STAFF REPORT 09-22-2021 MEETING

APPLICATION NUMBER: 21-7399

ADDRESS: 1445 GRISWOLD (AKA 1457 GRISWOLD/ ISAAC AGREE DOWNTOWN SYNAGOGUE)

SCOPE: REDESIGN STOREFRONT/REPLACE WINDOWS, NEW STAIRS/ELEVATOR PENTHOUSE

Applicant rendering.

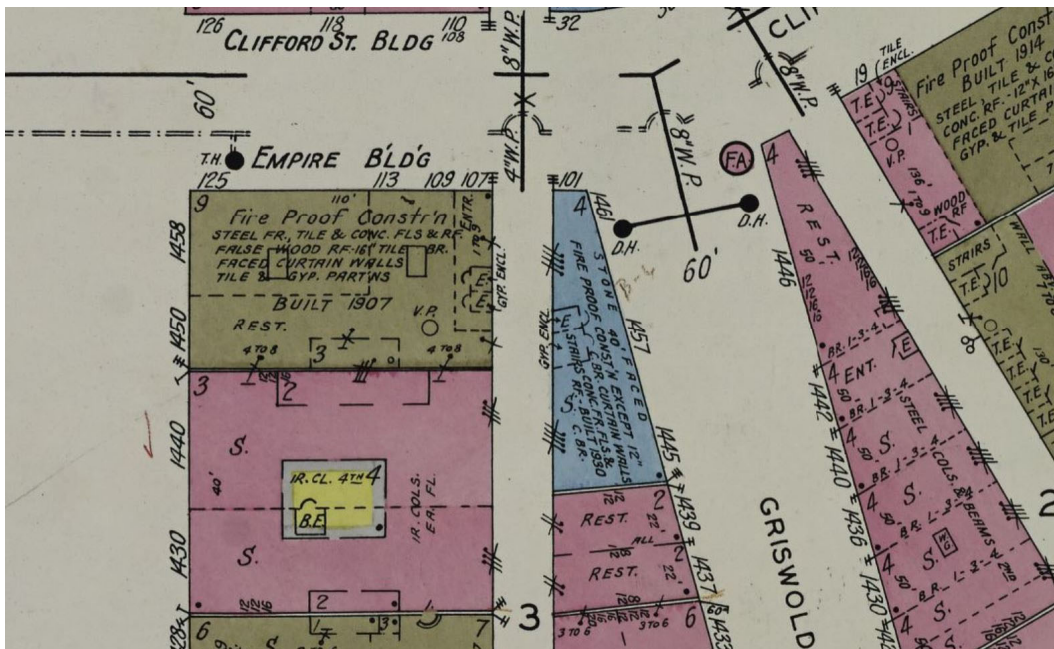
- The proposed design will daylight the long-closed storefront-type spaces at the first level, creating significant re-engagement with the streetscape and community life, principles of the Capitol Park Historic District rooted in its Elements of Design. The distinctive colored acrylic panels at the second floor, specifically mentioned in the Elements of Design, will be preserved. New windows at the first floor transom will be installed with colored films that extend this expression in a contemporary and appropriate manner.

- Though certain mid-century (and later) alterations to the first story will be removed, staff does not find that distinctive character-defining features will be impacted. In particular, the brown brick infill has long been an inappropriately blank expression, and created a wall in a zone designed for transparency. The proposed new materials and design appear to be appropriate and compatible with the established style and expression of the building, and consistent with the district’s Elements of Design.

The proposed work is compatible with the massing, size, scale and architectural features of its environment, and does not destroy historic materials that characterize the property. Staff therefore recommends that the proposal should qualify for a Certificate of Appropriateness, as it meets the Secretary of the Interior’s Standards and the Capitol Park Historic District’s Elements of Design.
